VALIDATION REPORT

For the renewal of crediting period (RCP) of GS - VPA

“Proyecto Mirador Enhanced Distribution of Improved
Cookstoves in Latin America - First VPA for
“Distribution of *Dos por Tres* Cookstoves in Honduras”
(GS Ref no. 2758)

REPORT NO.
GS.22.VAL.030

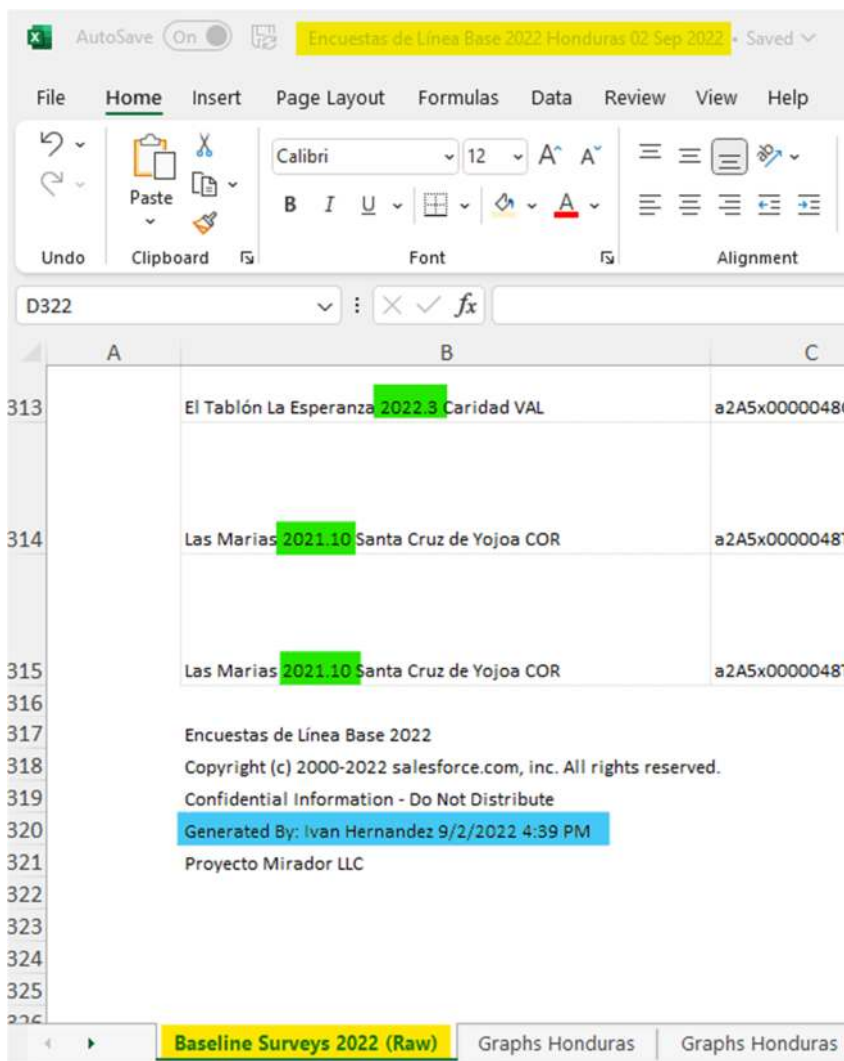
CAR ID	1	Section No.	GS Principles and Requirements	Date: 20/09/2022
Description of CAR				
<i>VPA-DD version 02.0, section B.4 is not depicting the latest results achieved during the survey performed during Sep 2022 to the sample of households for the baseline determination of the VPA.</i>				
CME Response				Date: 07/11/2022

Reference to the version of the VPA-DD is incorrect, the version shared was 1.0 (not 02.0, this corresponds to Gold Standard template version). The updated VPA-DD is now version 2.0.

Section B.4 does display the latest results from the latest baseline survey, which took place from 01/09/2021 to 31/05/2022. The date (02 Sep 2022) on the name of the file “Encuestas de Línea Base 2022 Honduras 02 Sep 2022” is not when the surveys took place, but rather when the report was generated from Mirador’s database in Salesforce and the information was processed.
